ACRA & Ballymun Road North Residents Associations

COLLINS AVENUE STATION MODULE 2

Paul Cusack on behalf of both Associations.

Figure 8-14 Collins Avenue Station Stage 2 –
Excavation and Piling Works

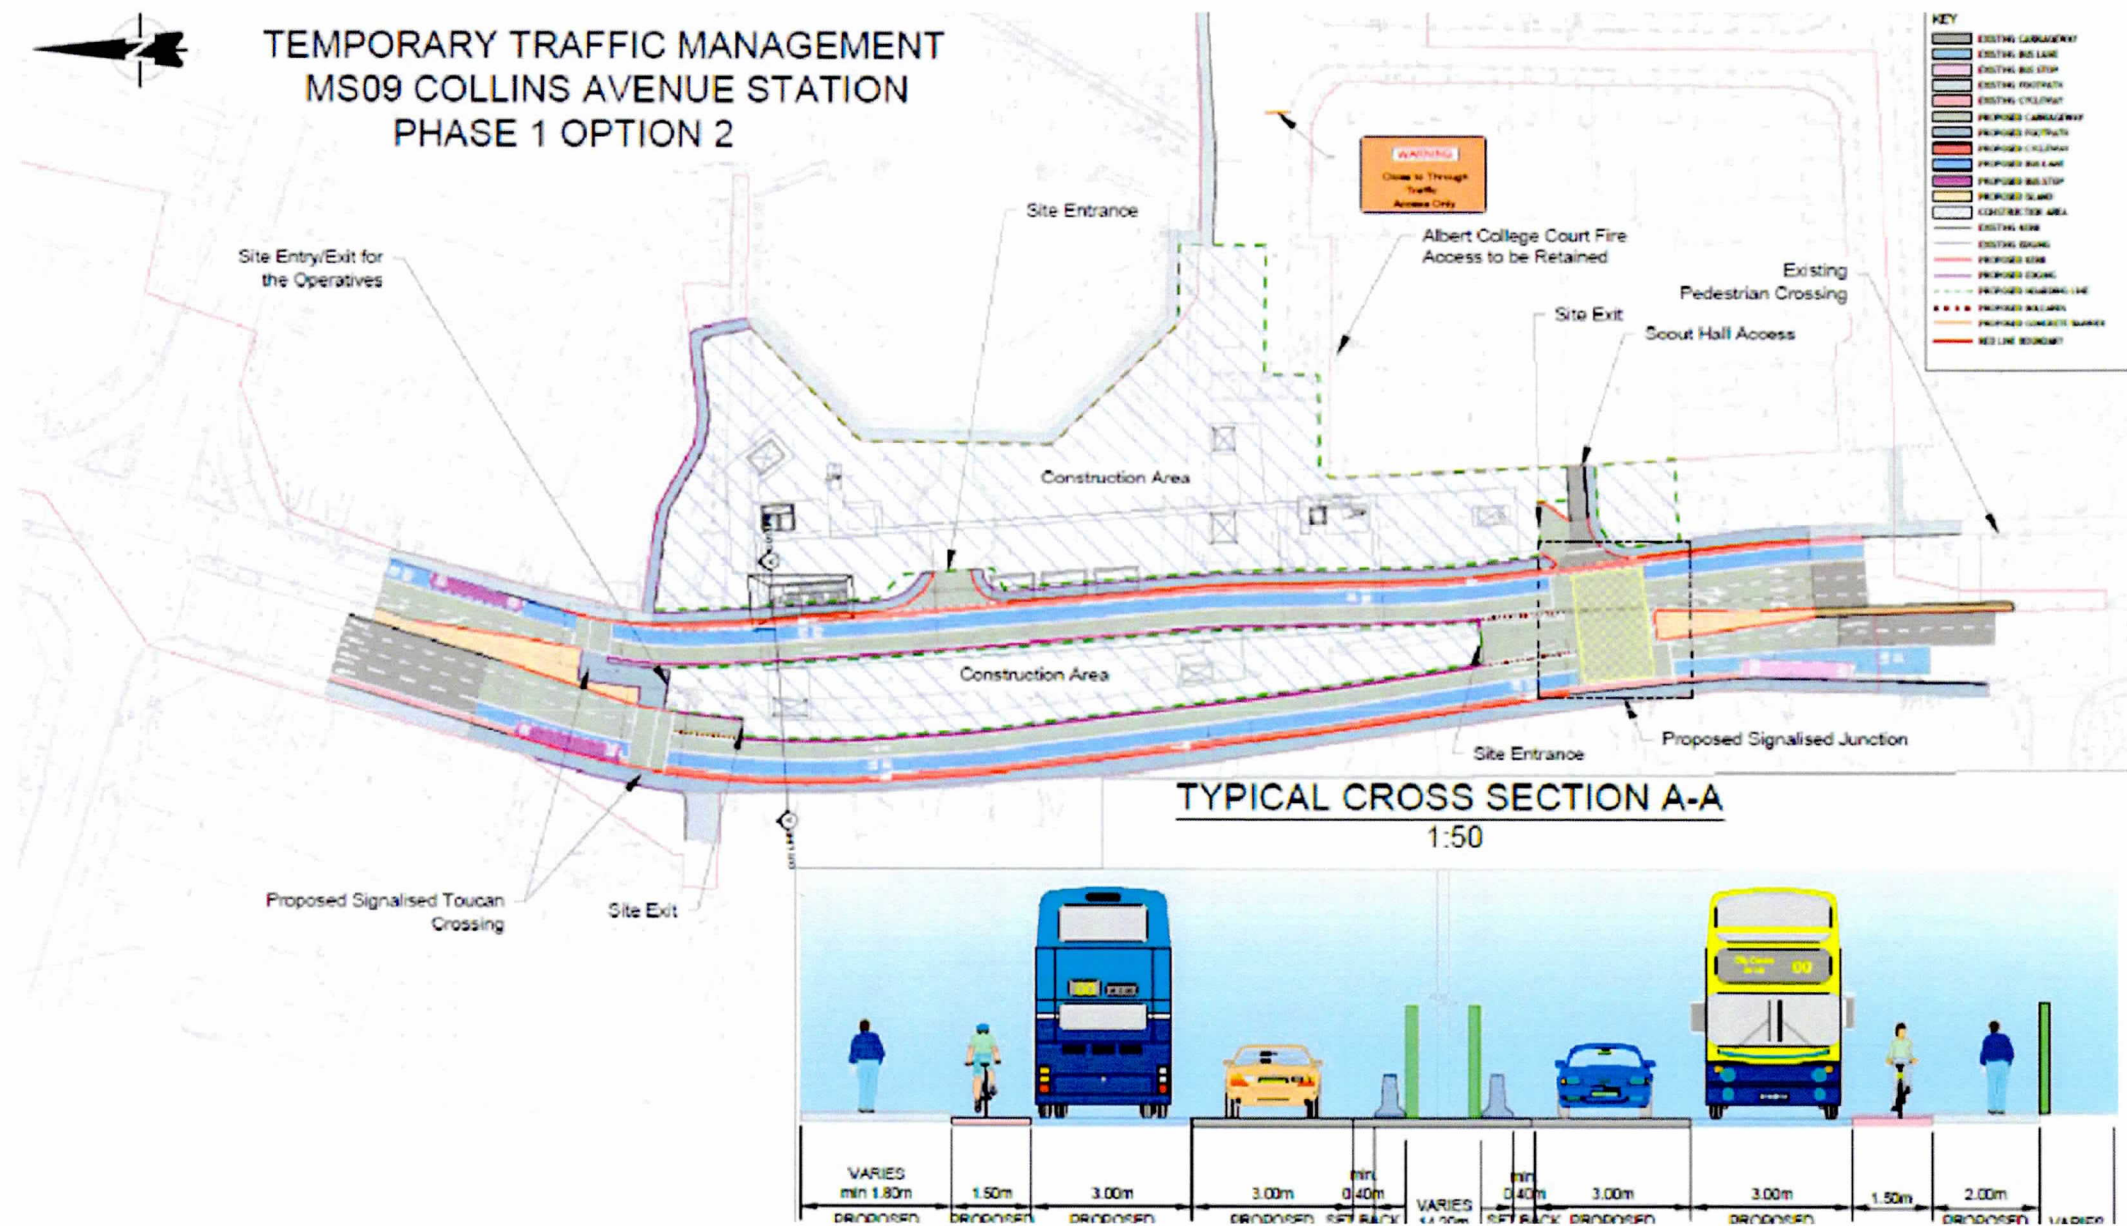
Up to 2 traffic lanes will be closed on each side of the road at different stages. South bound carriageways will be completely closed at some stages of construction

It will make safe access and egress to properties on both sides of Ballymun Road very difficult

Traffic will consistently be stationary on both carriageways as per the EIAR study

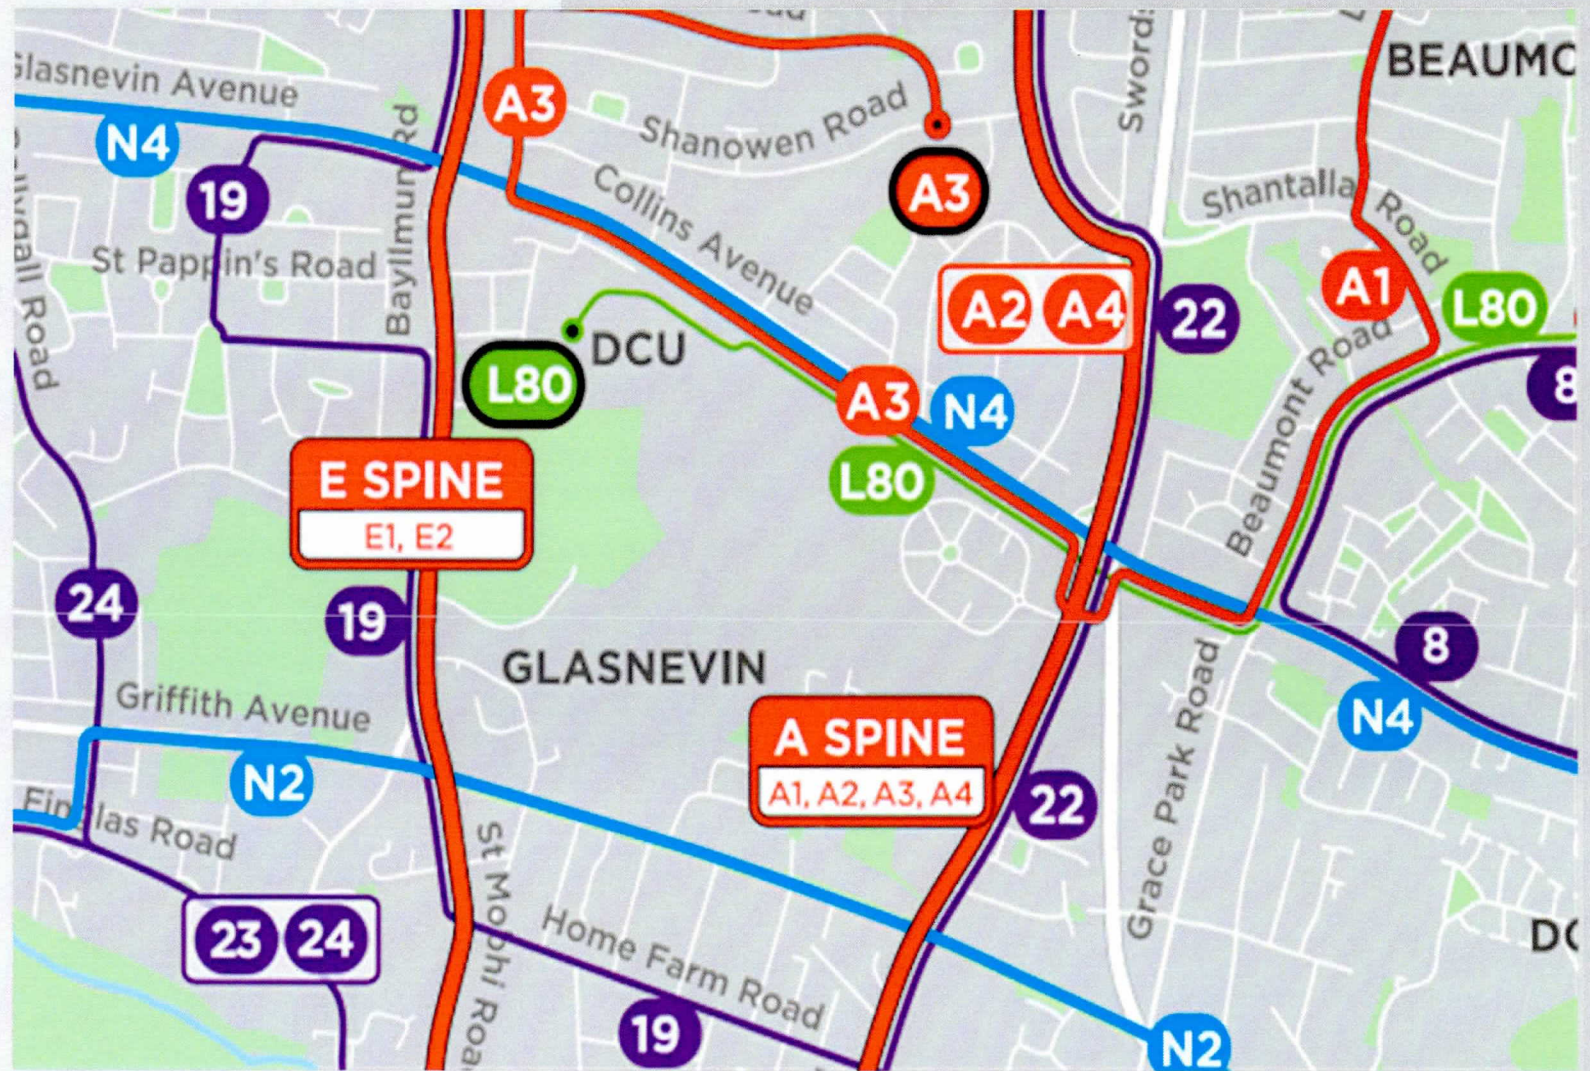
We continue to dispute this statement

- The claim is that passenger numbers will be higher, 17,250 per 24 hours at the church versus 12,250 at the park
- We request to see the study on which the above numbers are based
- “Within a 600m buffer from Collins Avenue Station there are more than 22 bus stops located along R108, R103 and Saint Pappin Road”
- There is only one main bus connects route on Glasnevin Ave/Collins Ave
- The N4 which travels east /west, all others are north/south spines
- What proportion of passengers will transfer from the N4 to MetroLink ?
- Metro North located the station at the bus stop at DCU entrance

(1) It allows the Project to achieve a core project objective of providing public transport that is integrated in the existing and future proposed transport network, providing for interchange between bus routes both on Collins Avenue and on Glasnevin Road.

A station location further south at the northern section of Albert College Park would not provide a good level of interchange as there would be over 500m separating potential bus stop locations on Collins Avenue and the MetroLink station.

Collins Avenue - Population

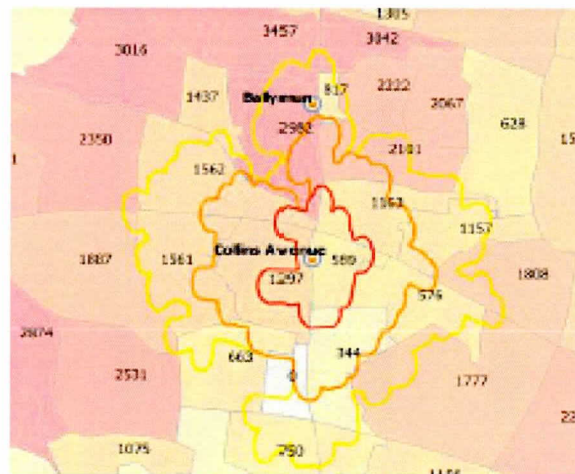
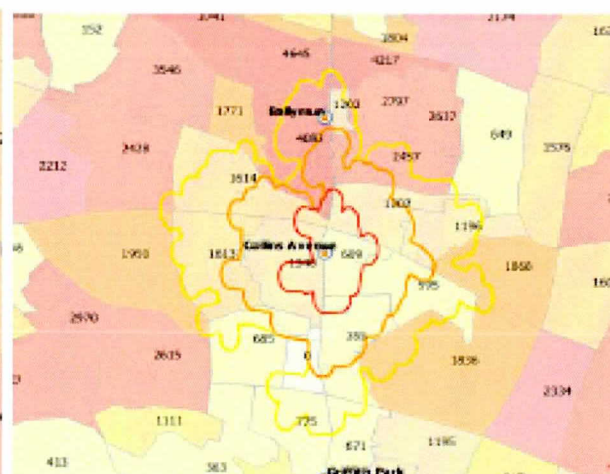
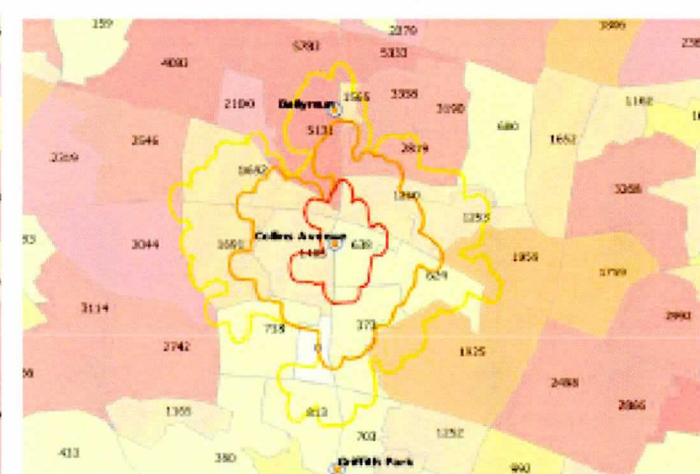
Is this an accurate representation ?

- The slides show population numbers in an area extending almost from Griffith Avenue in the south to well north of Ballymun Town
- There is another station in the middle of Ballymun Town
- The population is at its highest density in this area
- Why are the people who will obviously use Ballymun station being included in the numbers ?
- This has the effect of skewing the numbers which could be used as a justification for the station location

Figure 5.2: Origins of Boarding Passengers During AM peak hour within Walking Catchment Areas

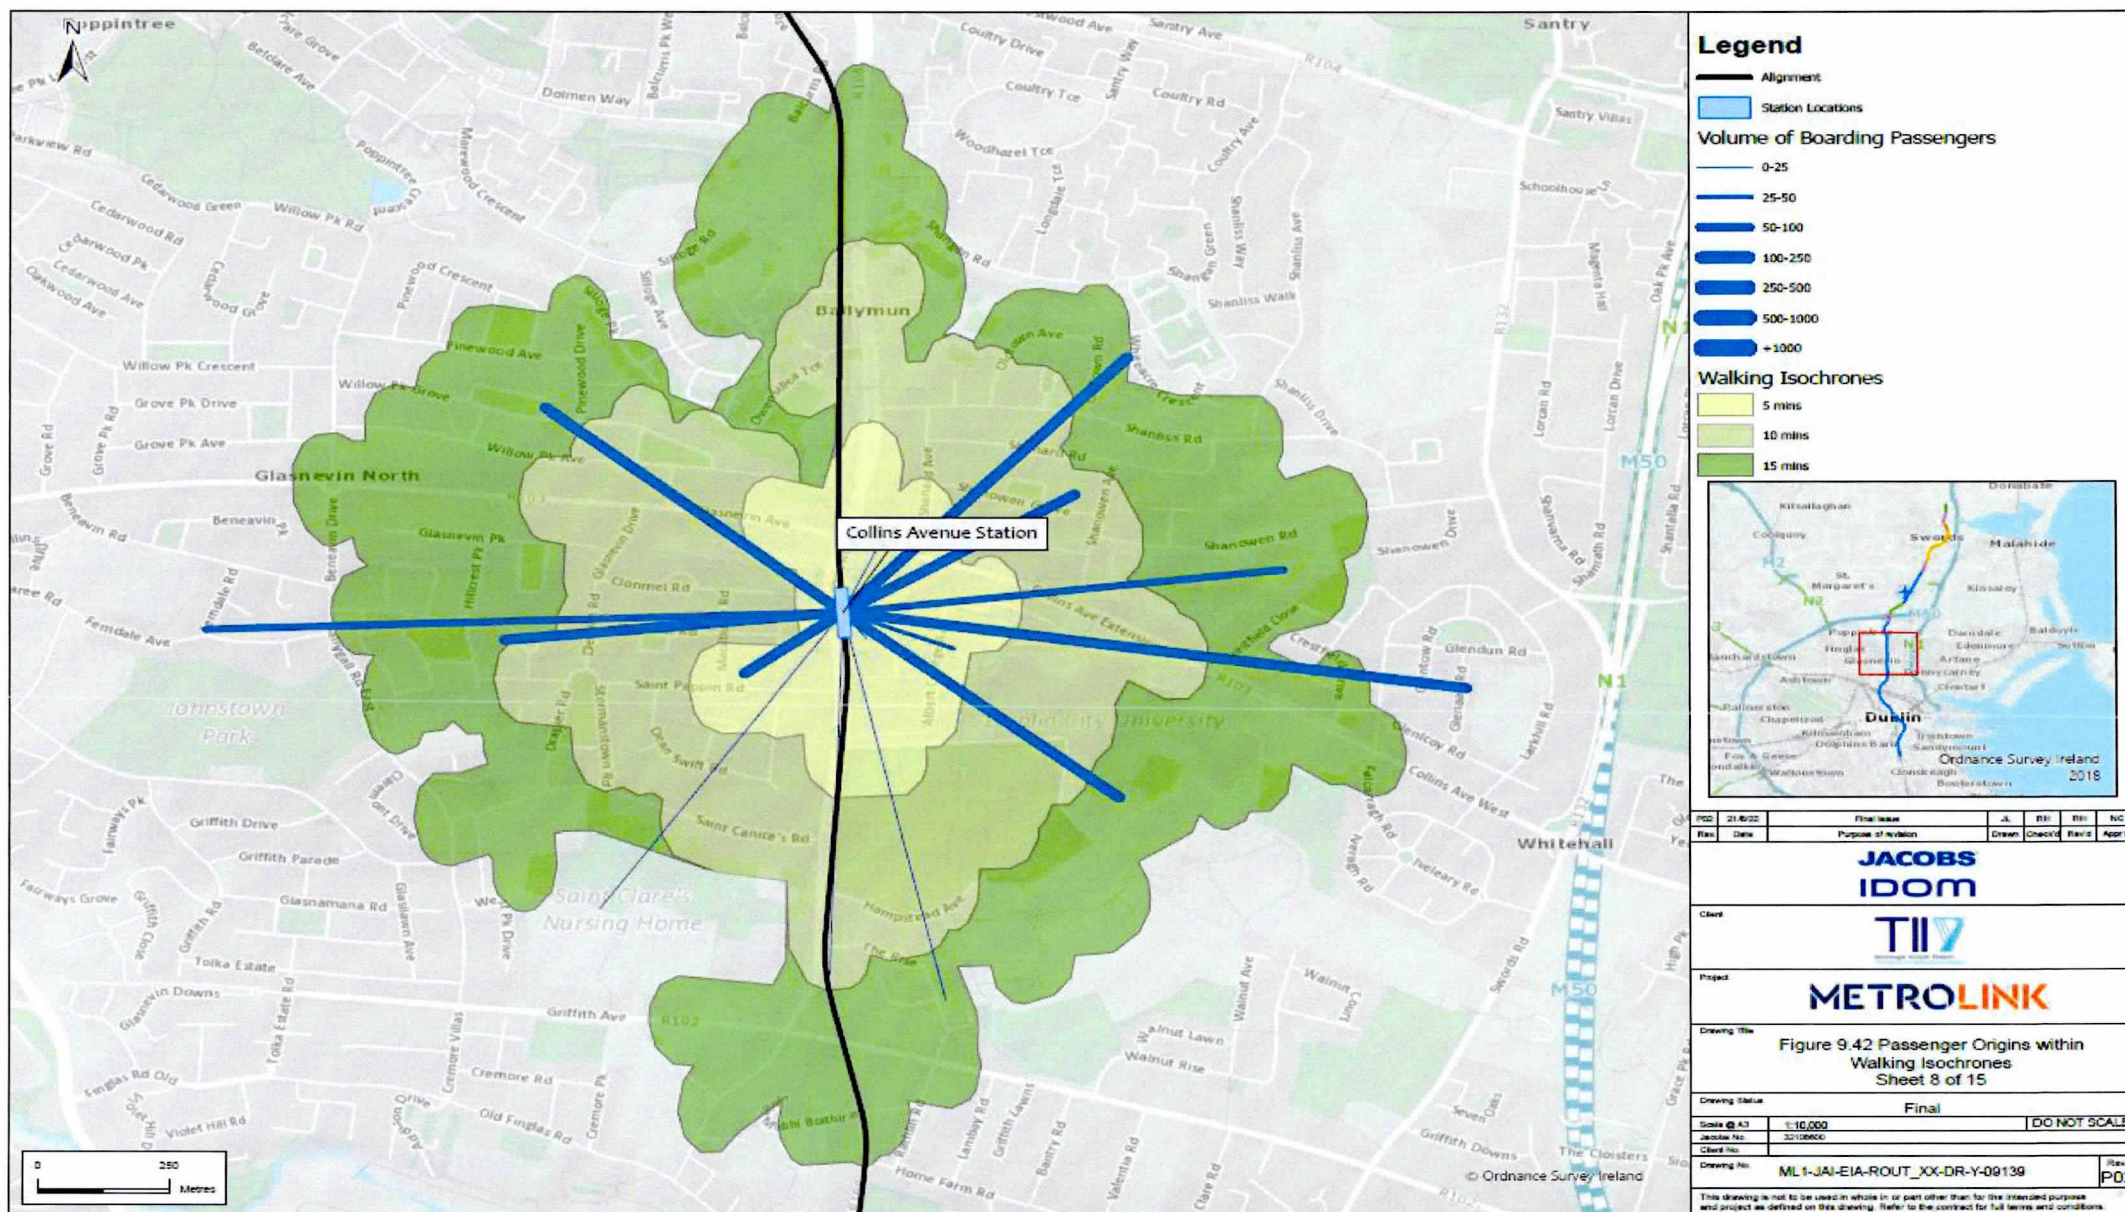
Our Observation :

- The main boarding passenger footfall appears to be from the mid-line and South of the midline
- The North-East and North-West Axis spines are mostly in closer proximity to the Ballymun Station and as on the previous slide should not be included
- Following is an excerpt from Traffic and Transport Assessment :

Figure 4.2 Collins Avenue Station Layout

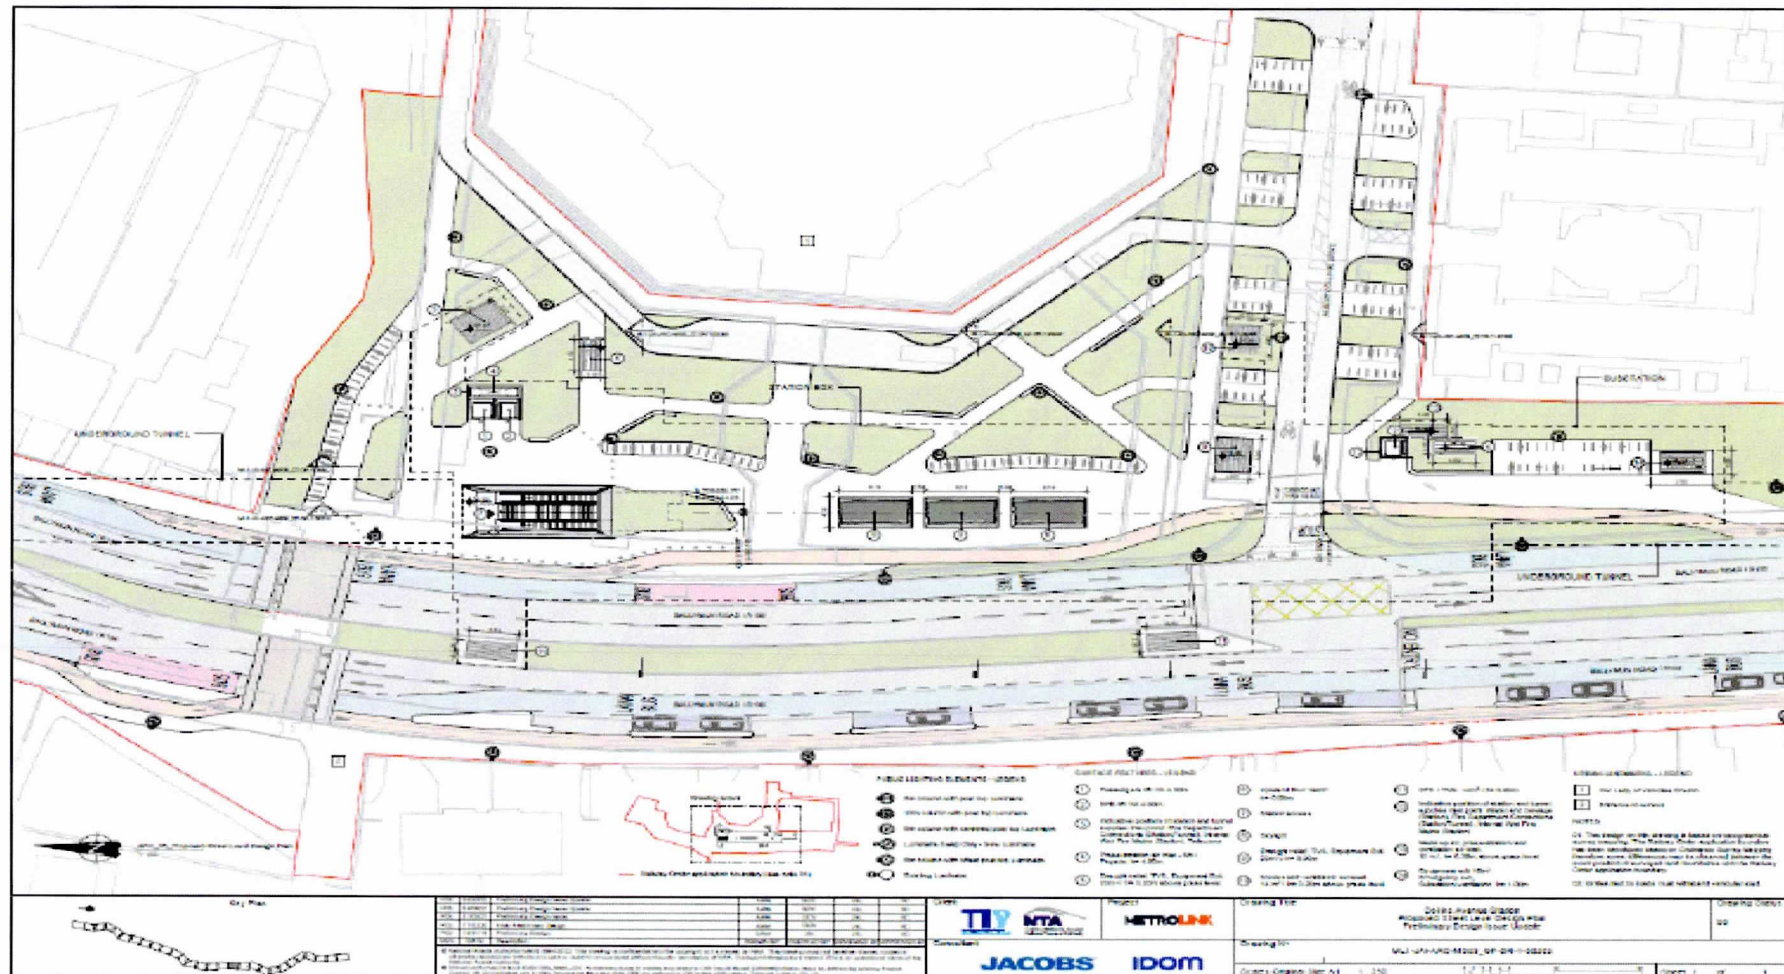
How does this make any sense ?

- This will be in addition to the proposal to put 370 bicycle parking bays at the station
- Car parking spaces on both sides of Albert College drive will be converted to these bicycle parking bays
- These spaces are heavily used for church services, funerals, school drop off and collection as well as residents of Albert Court, and visitors to the houses in the locale
- Who is going to use so many bike spaces ?
- Are the planners, by eliminating most of the available car parking spaces in the area trying to force senior churchgoers, parents of school children and elderly residents to get out of their cars and cycle to and from the church, schools or their homes ?
- These plans are bordering on ridiculous and are totally unfair
- They show a complete lack of empathy and respect for the local community
- These plans will severely erode goodwill in the area
